**TSG-RAN**  
**December 6-8, 2000**  
**Bangkok, Thailand**

**Title:** Comments on LS from RAN WG4 on coexistence of 1.28Mcps TDD and 3.84 Mcps TDD  
**Source:** Telia AB  
**Agenda Item:** 4.3  
**For:** Discussion and decision

**Fig. 1** Two synchronisation alternatives where either the 1.28 Mcps TDD operator or the 3.84 Mcps TDD operator concede to give up one time slot per frame.

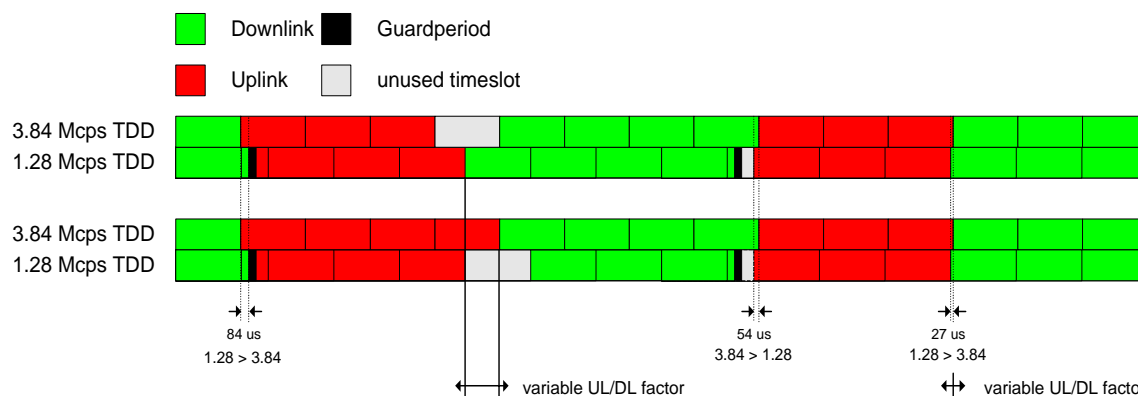
Trying to synchronise the two incompatible frame-structures as much as possible (see Fig. 1) the result is still deterrent:

- One of the two competing operators has to give up one timeslot per frame  
 ⇒ 7% capacity loss  
 ⇒ Nightmare scenario for inter-operator co-ordination negotiations.
- Every second UpPTS (1.28 Mcps TDD), used for random access, is killed by interference.
- In addition to the unused timeslot, up to 40% (1.5 dB) of the capacity is lost for timeslots where up and downlink timeslots are partially overlapping (see Fig. 1).

This should be compared to the complete interference suppression achievable with compatible frame structures.

We propose, however, that RAN WG1 and RAN WG4 should be given the task to find a solution to the identified problems.
